PARTS & SERVICE NEWS

REF NO.	AT02056
DATE	Jul. 12, 2002

SUBJECT: MODIFICATION PROCEDURE OF WINDOW MOTOR FAILURE ON HM300, 350, 400-1

PURPOSE: To introduce modification procedure to prevent occurrence of failures with the power window related parts on HM300-1, HM350-1 and HM400-1 dump trucks

<Electric circuit diagram for the power window, before the modification>

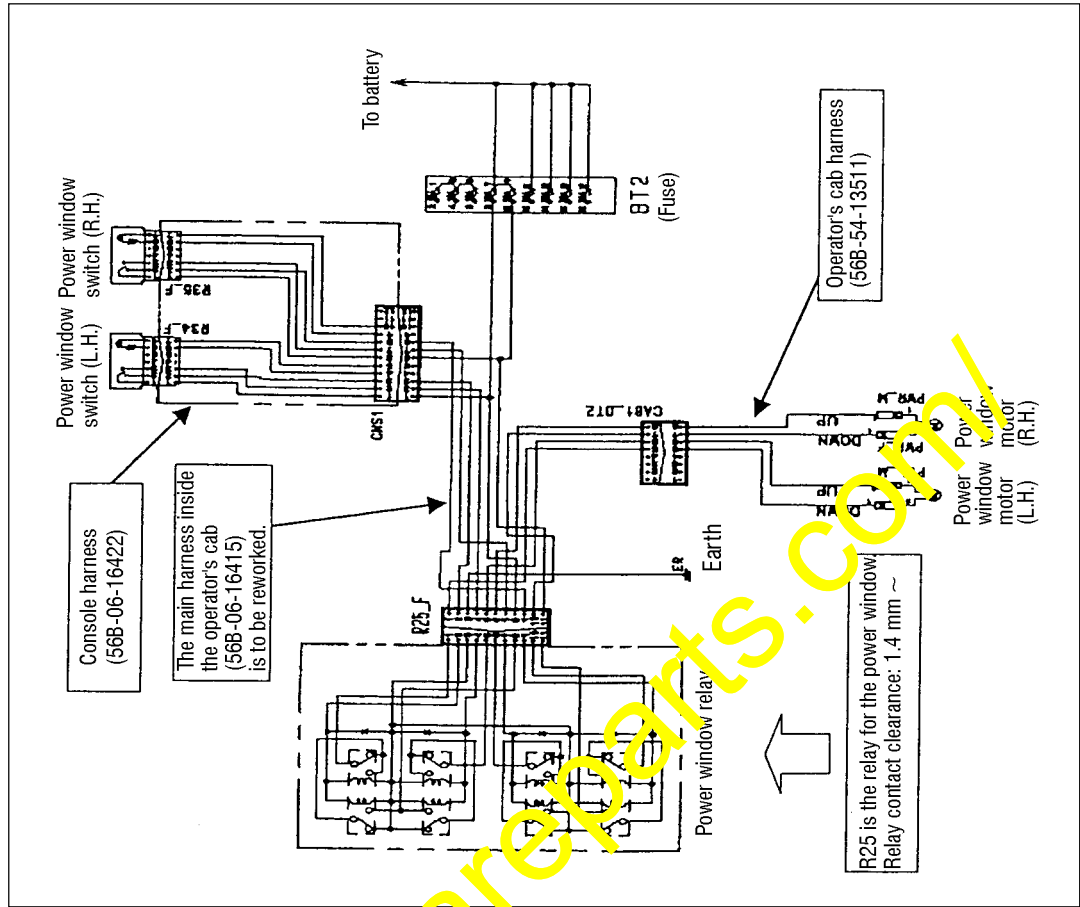
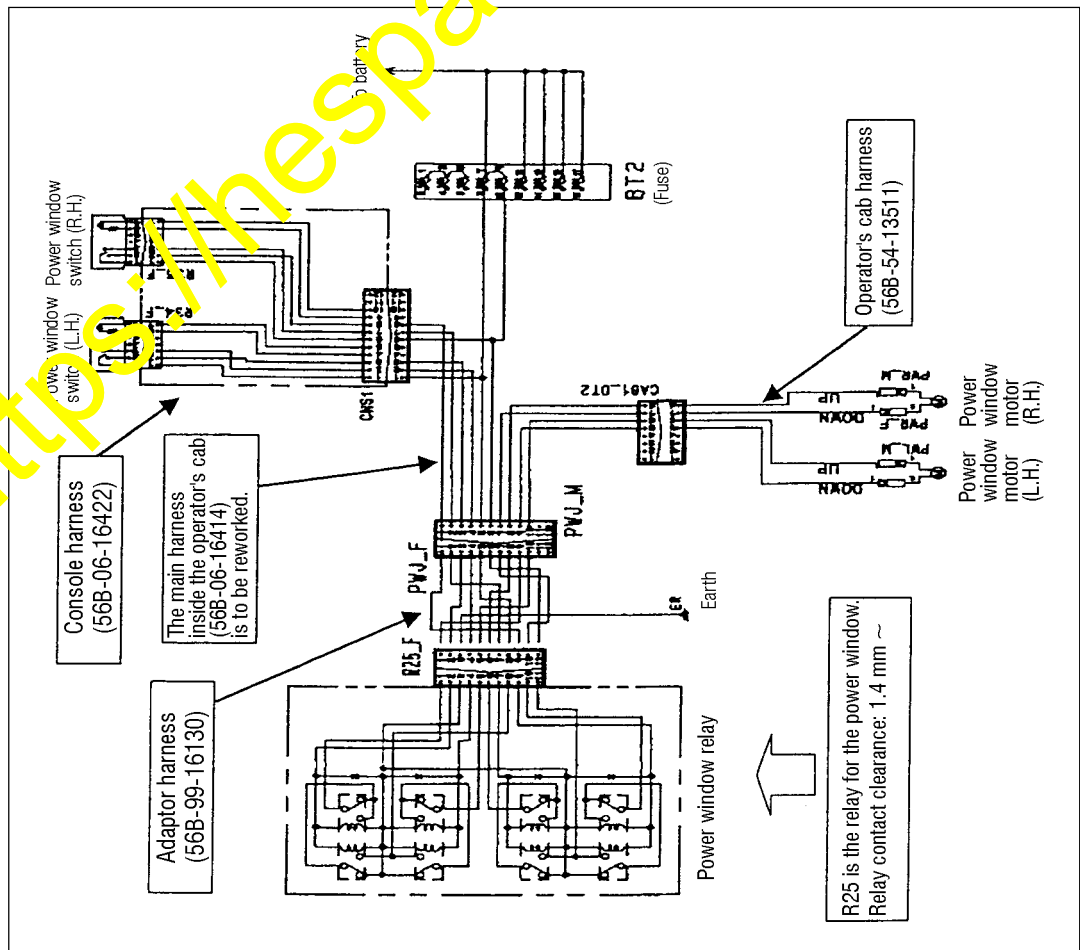
- (1) Replacing the power window relays (4 pcs.), modifying the main harness inside the operator's cab.
- (2) Changing the relay label being applied inside the operator's cab.

<Power window circuit diagram after the modification>

Fig. 4

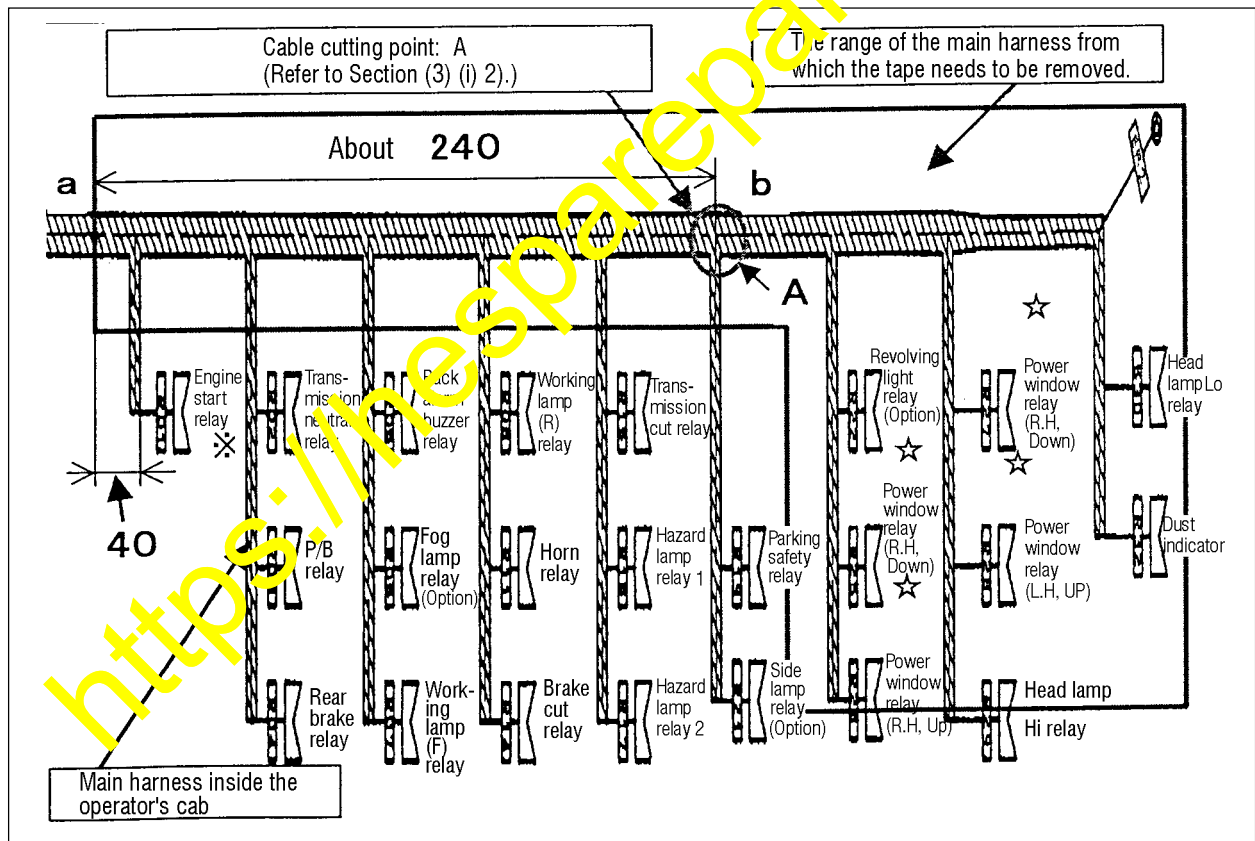
(R25, R26, R27 and R28 : sections marked ☆ in Fig. 4 to the new connector (PWJ)

- 2) Cut the separated leads at a point near the section "A" (Note 4) (Refer to Fig. 4.) once again at equal lengths (The distance a-b in Fig. 4: (240 mm)) (Note 3) and remove the insulation covering by 7 mm.
(Total 10 leads. Use the stripper or other generally marketed tools as the insulation covering removing tool.)

Fig. 5

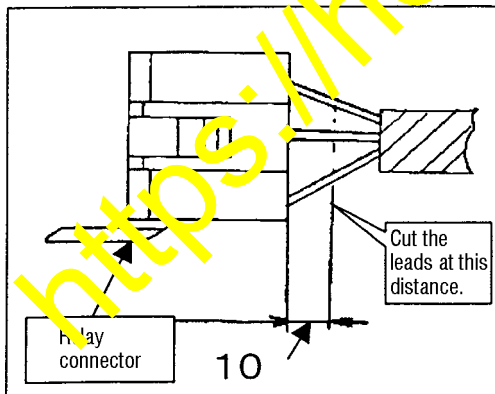
- (i) Connect the leads of the relay connectors (R25 through R28) (Refer to Fig. 6) to the centralized connector (PWJ). (Refer to Fig. 7.)
 - 1) Using the nipper or radio priers, cut to separate the leads at a distance 10 mm away from the relay connector end. (Note 3)
(Total 20 leads. Refer to Fig. 5.)

Fig. 7

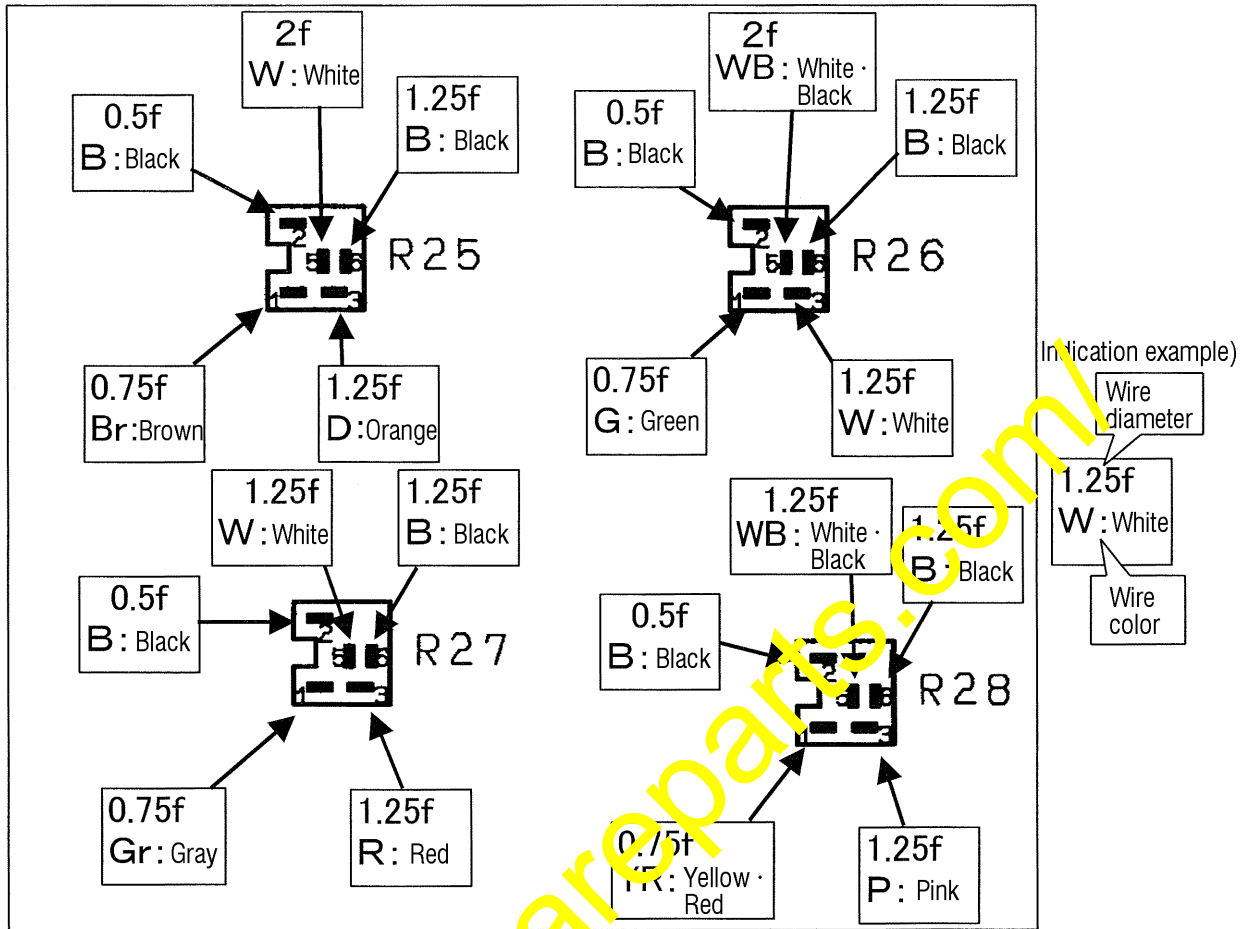
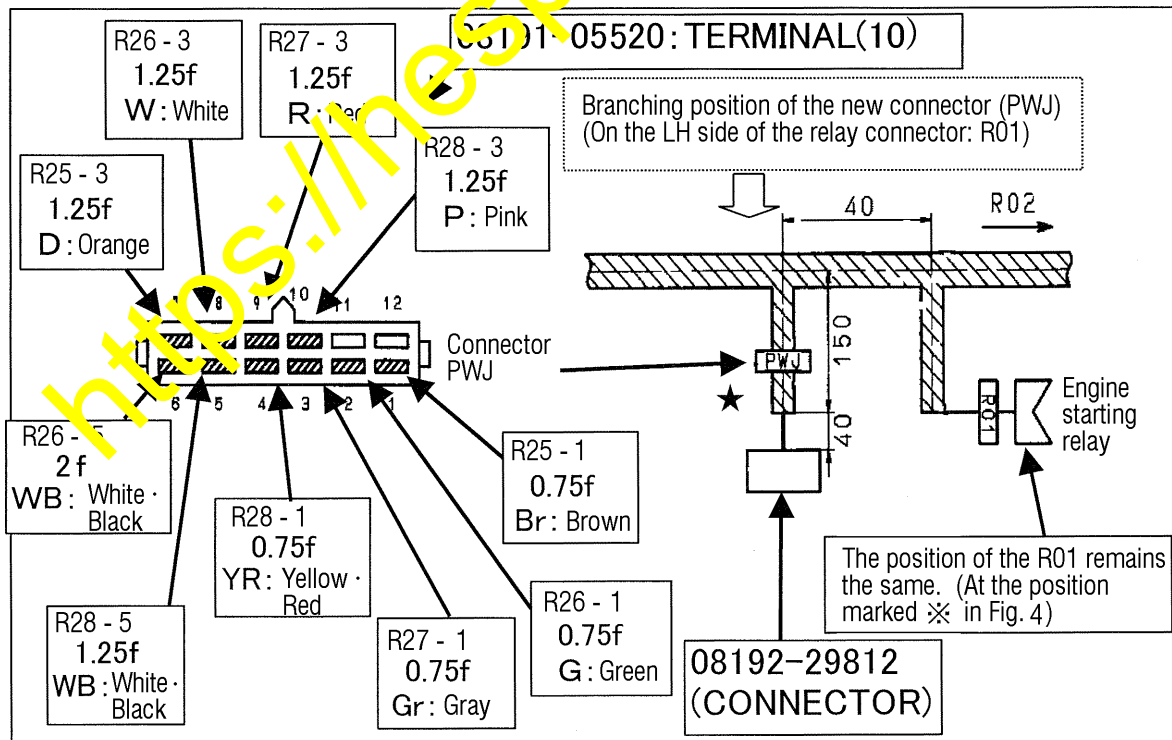
- 4) Install the terminal into the new connector (08192-29812) (PWJ).
(Refer to Fig. 7.)
 - 5) After installing all the terminals, insert the wedges (green colored wedges) being attached to the connector to fasten the terminals. (When the wedge is pushed in, the lock will be applied to fasten the terminal.)

Fig. 8

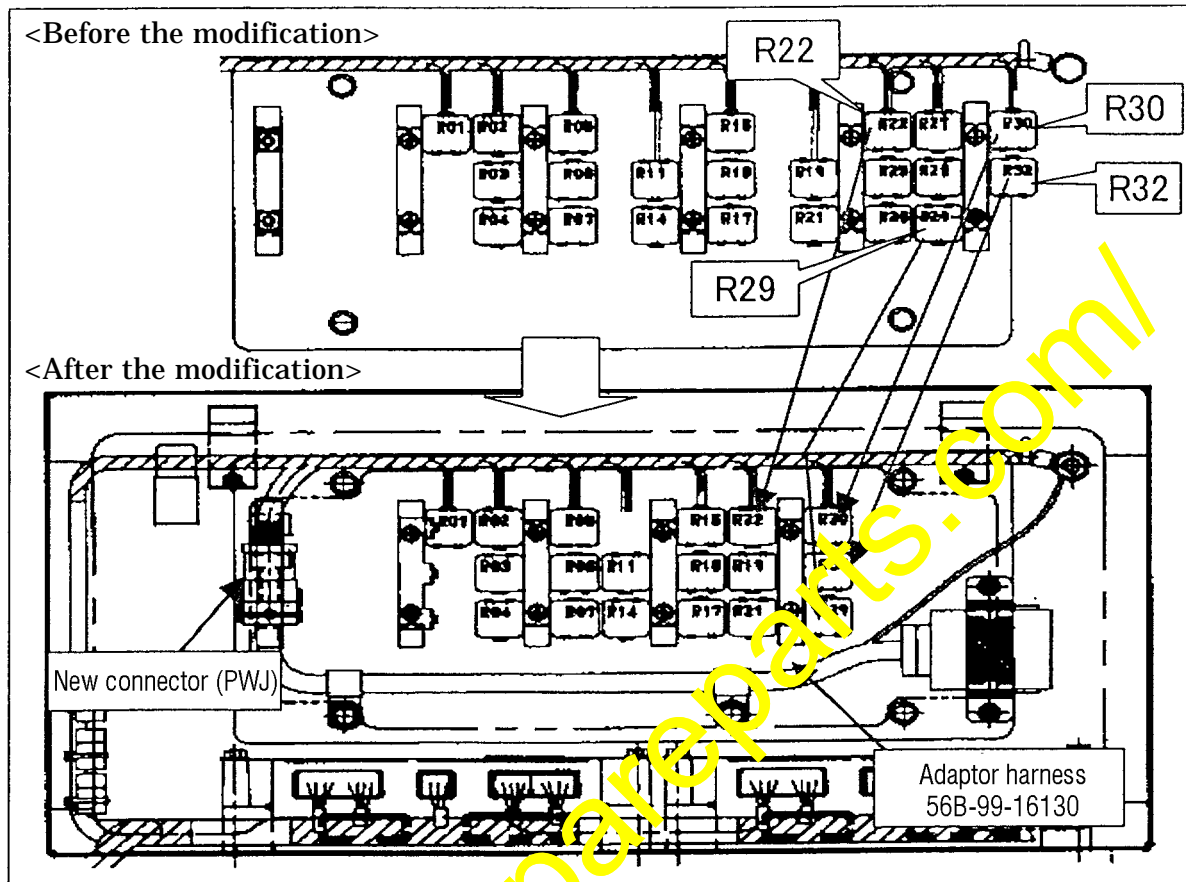
- (4) Changing the layout of the relay connectors (R22, R29, R30 and R32)
- (i) Change the layout of the relay connectors (R22, R29, R30 and R32) as shown below. (Refer to Fig. 8)

Fig. 9

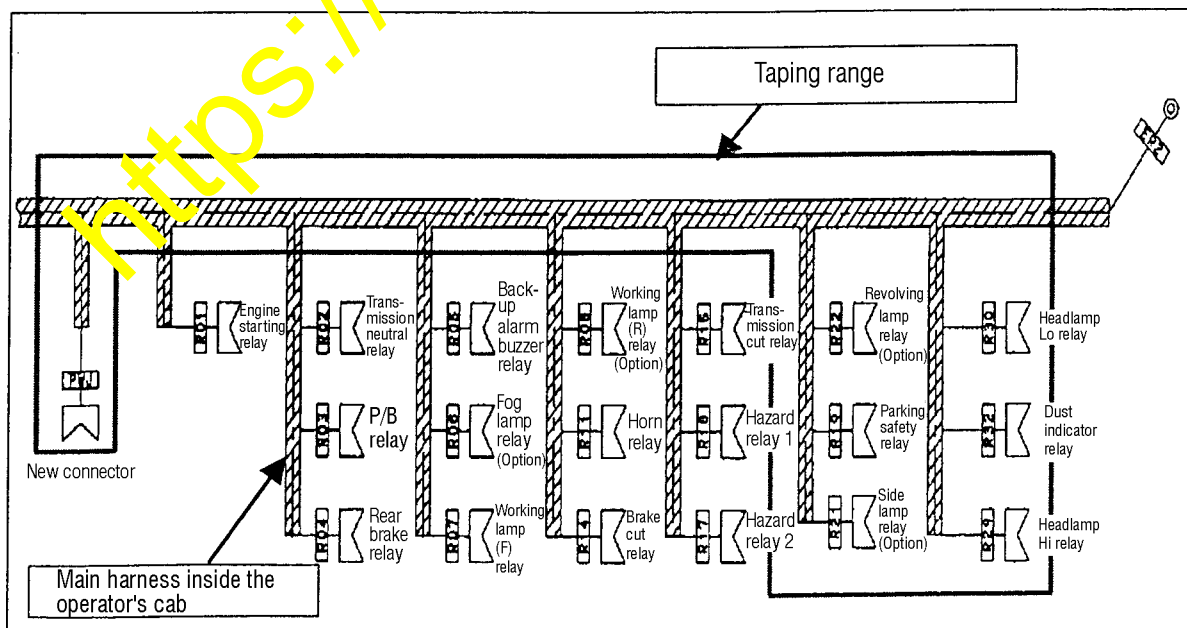
- (ii) Apply insulation taping to the excess leads which became excessive by the above change of the relay layout and to the leads separated as per the above Section 4-3A(2). (Tape No. 60024-91920) (Refer to Fig. 9)

Fig. 13

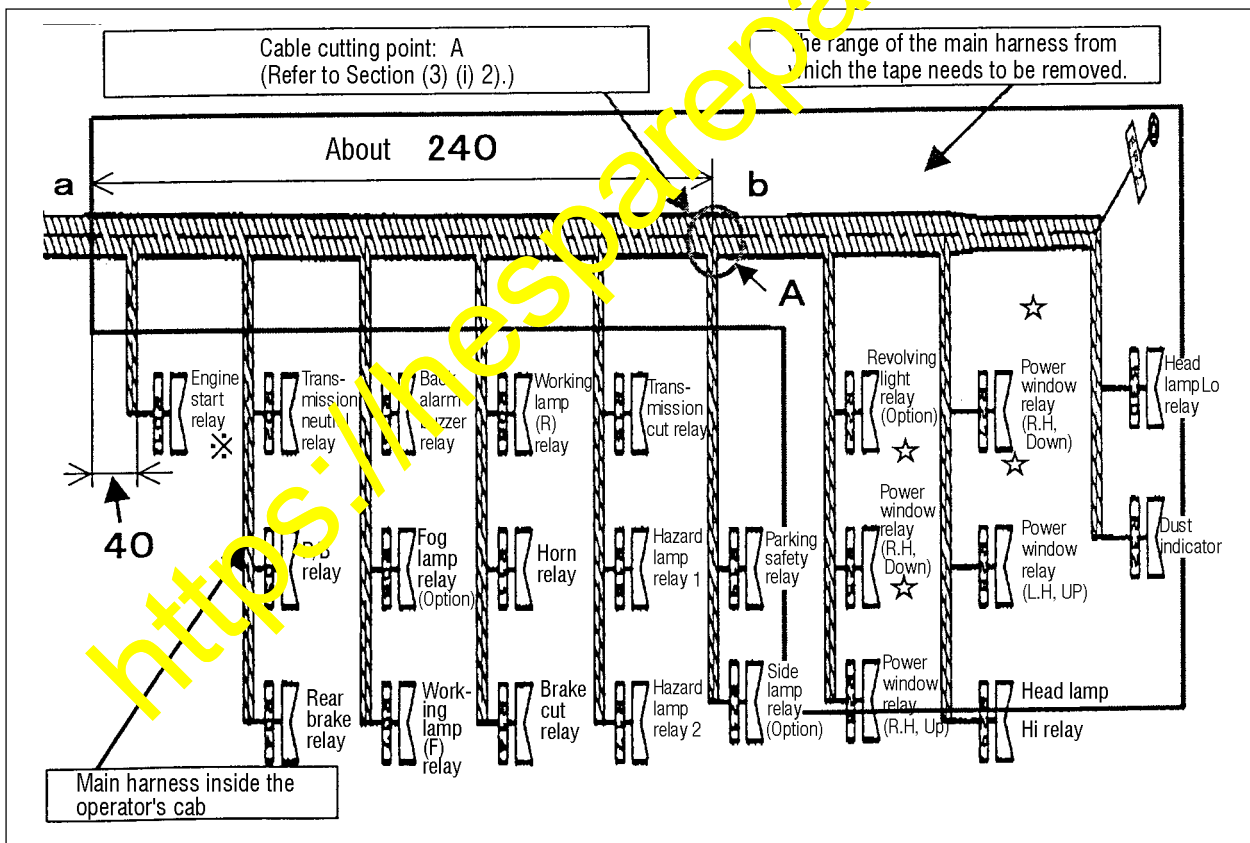
(R25, R26, R27 and R28 : sections marked ☆ in Fig. 13 to the new connector (PWJ)

- 2) Cut the separated leads at a point near the section "A" (Note 6) (Refer to Fig. 13.) once again at equal lengths (The distance a-b in Fig. 13: (240 mm)) (Note 5) and remove the insulation covering by 7 mm.
(Total 10 leads. Use the stripper or other generally marketed tools as the insulation covering removing tool.)

Fig. 14

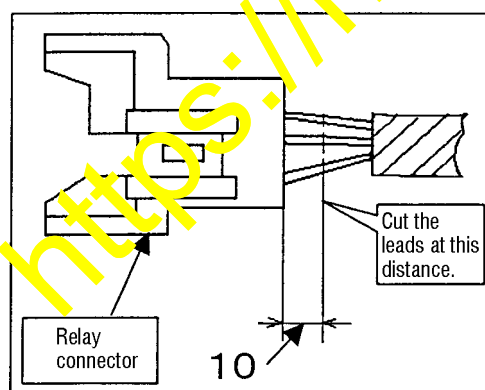
- (i) Connect the leads of the relay connectors (R25 through R28) (Refer to Fig. 15) to the centralized connector (PWJ). (Refer to Fig. 16.)
 - 1) Using the nipper or radio pliers, cut to separate the leads at a distance 10 mm away from the relay connector end. (Note 5)
(Total 20 leads. Refer to Fig. 14.)

Fig. 16

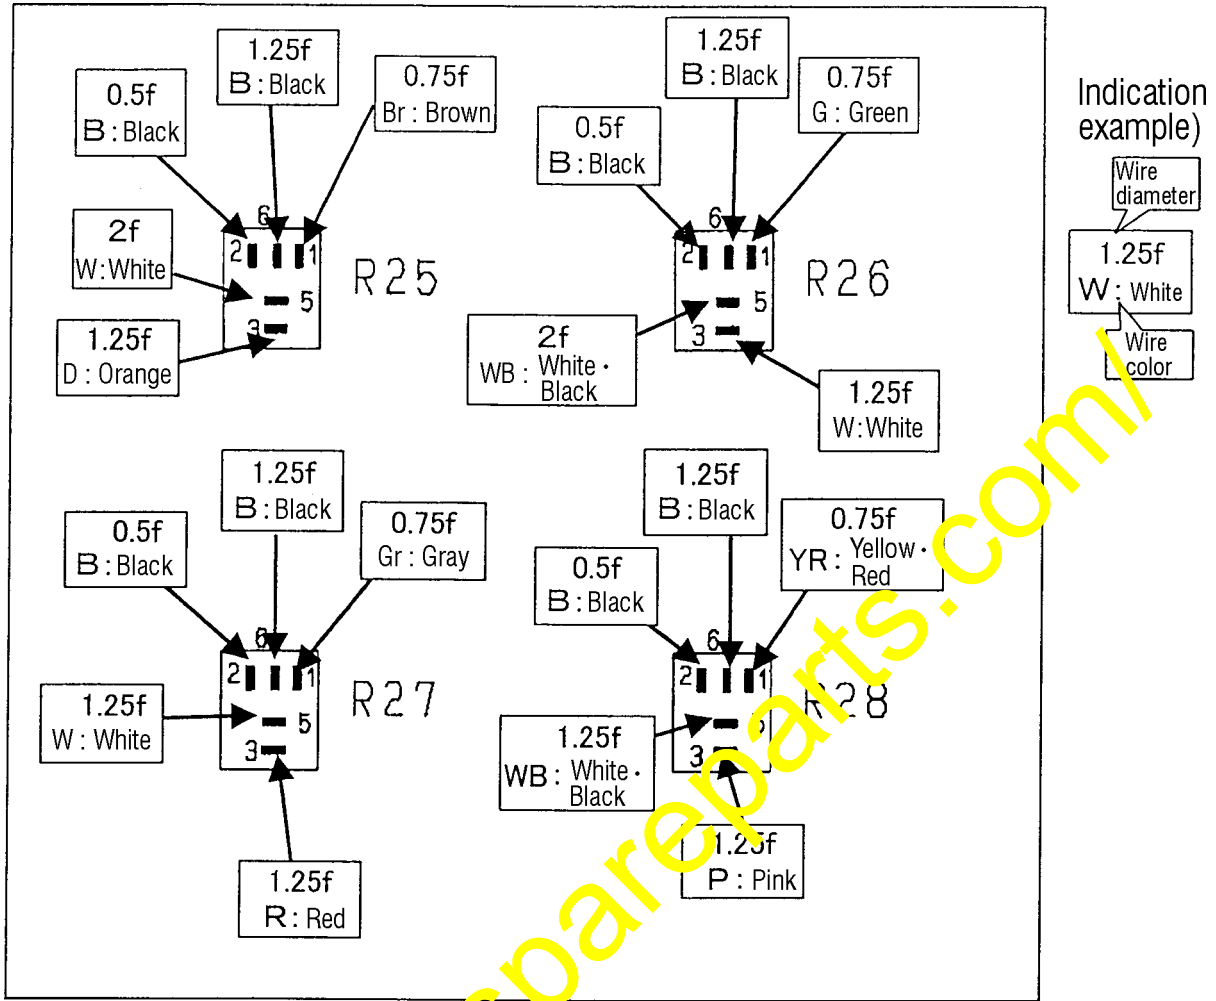
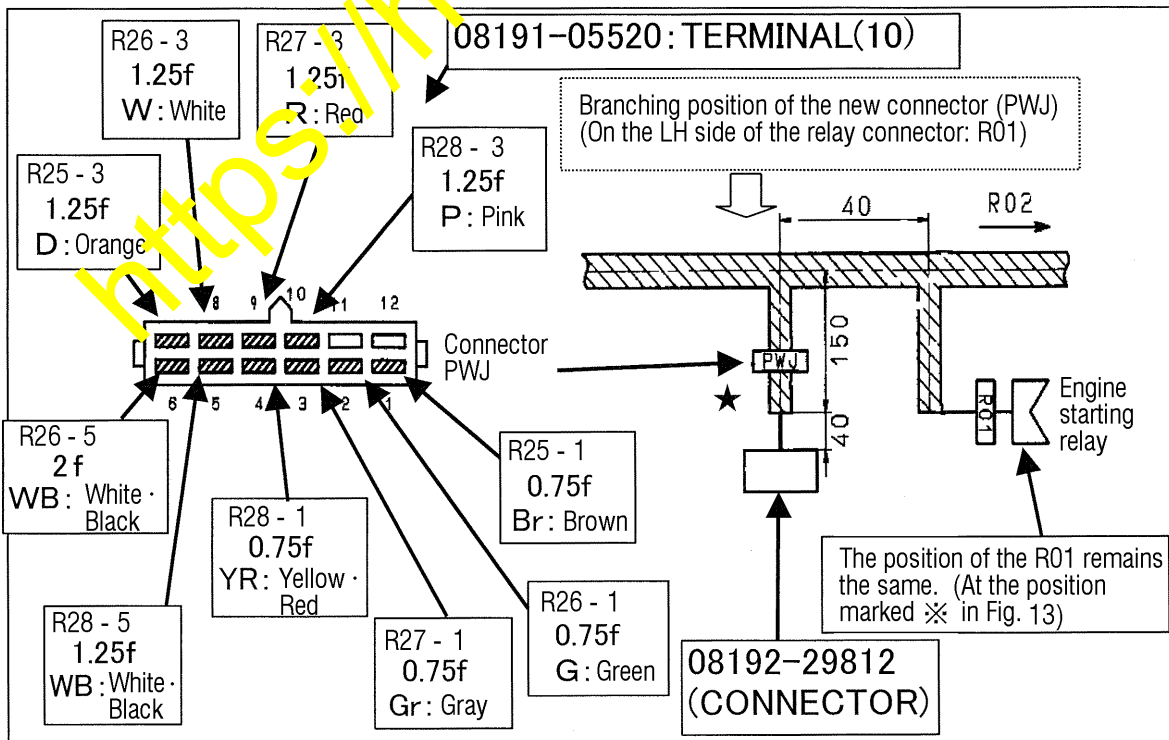
- 4) Install the terminal into the new connector (08192-29812) (PWJ).
(Refer to Fig. 16.)
 - 5) After installing all the terminals, insert the wedges (green colored wedges) being attached to the connector to fasten the terminals. (When the wedge is pushed in, the lock will be applied to fasten the terminal.)
